Access Compliance Report

Public Rights-of-Way

Intersection ID: 3537	Main Street: MT_ISLE_HARBOR_DR	Cross Street: SHIMMERING_LAKE_DR	Location:	W
ADA ID: 956044065269	Ramp Type: Perp	Initial Pass/Fail: Fail	Overall Compliance: No	Severity Score: 22.5

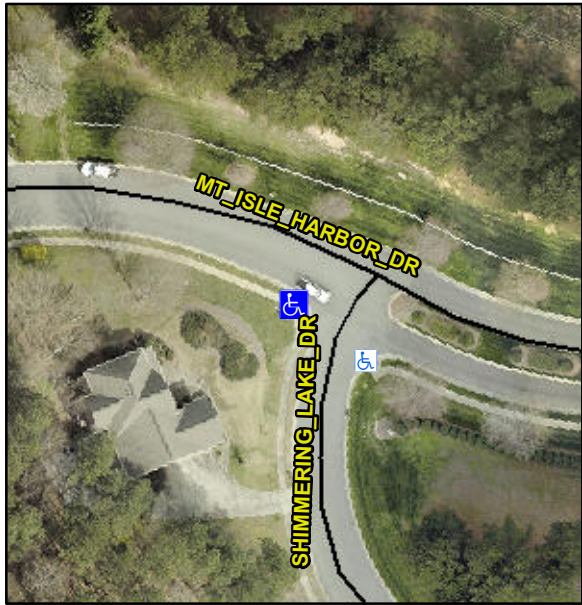
Codes/Mitigation Info/Possible Solution			Field Measurements/Component Compliance					
	Possible Solutions:		Compliance	Description	Data	Compliance	Description	Data
	Remove & Replace Entire Ramp.		N/A	Ramp Length (in)	45.0	No	Ramp Slope (%)	11.1
			No	Ramp Width (in)	46.0	No	Ramp XSlope (%)	4.7
			N/A	Flare Type LT	N/A	N/A	Flare Type RT	N/A
			N/A	Flare Slope LT (%)	N/A	N/A	Flare Slope RT (%)	N/A
			N/A	Flare Traversable LT?	N/A	N/A	Flare Traversable RT?	N/A
			N/A	Landing Length (in)	N/A	N/A	DWS Provided?	N/A
			N/A	Landing Width (in)	N/A	N/A	DWS Contrast?	N/A
			N/A	Landing Slope (%)	N/A	N/A	DWS Length (in)	N/A
			N/A	Landing X Slope (%)	N/A	N/A	DWS Full Width?	N/A
Surveyor Notes:	N/A		N/A	Landing Curb? (Y/N)	N/A	N/A	DWS Offset (in)	N/A
			N/A	Shared Landing?	N/A			
	PROW/ADA:		N/A	Gutter Ponding?	N/A	N/A	Gutter Slope (%)	N/A
	Not Found, R304.5.1, R304.2.2, R304.5.3		N/A	Gutter Lip Ht (in)	N/A	N/A	Gutter X Slope (%)	N/A
